Access Compliance Report

Public Rights-of-Way

(Curb Ramps)

Intersection ID: 9648	Main Street: TIMBERBROOK_DR	Cross Street: TUCKASEEGEE_RD	Location: SE
ADA ID: A18238BB6C89	Ramp Type: Directional1	Initial Pass/Fail: Fail	Overall Compliance: No
			Severity Score: 13.75

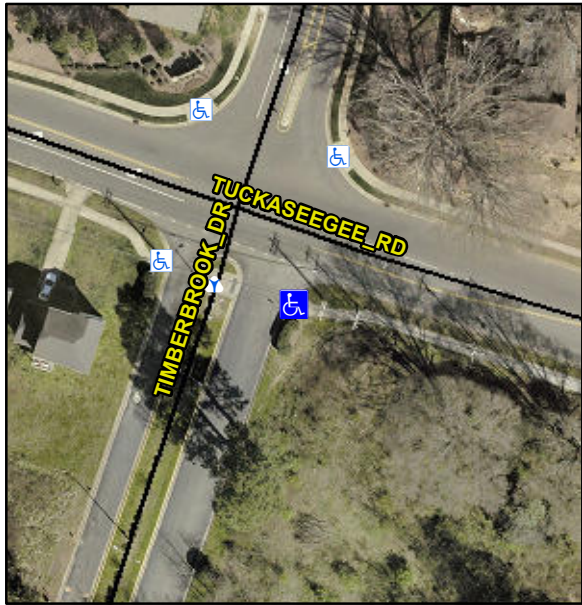
Codes/Mitigation Info/Possible Solution			Field Measurements/Component Compliance					
	Possible Solutions:		Compliance	Description	Data	Compliance	Description	Data
	Remove & Replace Entire Ramp.		N/A	Ramp Length (in)	59.0	N/A	Grade Break?	N/A
			Yes	Ramp Width (in)	70.5	N/A	Grade Break Slope (%)	0.0
			No	Ramp Slope (%)	9.4	N/A	Grade Break XSlope (%)	0.0
			No	Ramp XSlope (%)	2.2			
			N/A	Flare Type LT	N/A	N/A	Flare Type RT	N/A
			N/A	Flare Slope LT (%)	N/A	N/A	Flare Slope RT (%)	0.0
			N/A	Flare Traversable LT?	N/A	N/A	Flare Traversable RT?	N/A
			N/A	Landing Length (in)	0.0	N/A	DWS Provided?	N/A
			N/A	Landing Width (in)	0.0	N/A	DWS Contrast?	N/A
Surveyor Notes:		N/A	N/A	Landing Slope (%)	0.0	N/A	DWS Length (in)	N/A
		N/A	N/A	Landing X Slope (%)	0.0	N/A	DWS Full Width?	N/A
PROW/ADA:		N/A	N/A	Landing Curb? (Y/N)	N/A	N/A	DWS Offset LT (in)	N/A
R304.2.2, R304.5.3		N/A	N/A	Shared Landing?	N/A	N/A	DWS Offset RT (in)	N/A

N/A	N/A	Gutter Ponding?	0.0	N/A	Gutter Slope (%)	N/A
		N/A	N/A	Gutter Lip Ht (in)	0.0	N/A	Gutter X Slope (%)	N/A
		N/A	N/A	Painted X Walk1?	No		Road Slope (%)	0.1
				X Walk 1 Direction	To W		Road X Slope (%)	5.9
				X Walk 1 Width (in)	N/A		Clear Space?	N/A
				X Walk 1 Slope (%)	0.1	N/A	Clear Space to XWalk (in)	N/A
				X Walk 1 X Slope (%)	5.9	N/A	Storm Grate/Utility Hazard?	N/A
		N/A	N/A	Ramp inside XWalk1?	N/A		Storm Grate/Utility Type	
		N/A	N/A	Any Obstructions?	N/A			N/A
				Obstruction Type		Yes	Surface Condition? (G/P)	Good
					N/A	N/A	Curb Slope (%)	9.7
Total Cost:		\$ 1600.00
